FR Technical Advisory Memo

- Nº: TAMFR-2020-031
- Date: September 11, 2020

Subject: Reducing ECU temperature

Spacers in place

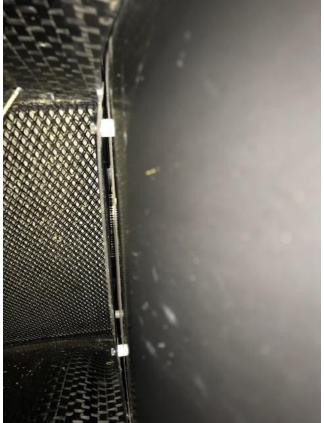
Beginning at VIR, Ligier has provided spacers which, when installed between the tub and the inlet duct in the right sidepod, have been shown to decrease ECU temperatures and reduce the risk of the ECU shutting down the engine during pace laps or on pit lane.

Effective immediately, these may be installed as an optional update for the remainder of the 2020 season events at Sebring, Homestead, and COTA. The spacers are available at the Ligier trailer.

Removing the foam surrounding the ECU has also been shown to decrease ECU temperatures. Teams are permitted to do so.
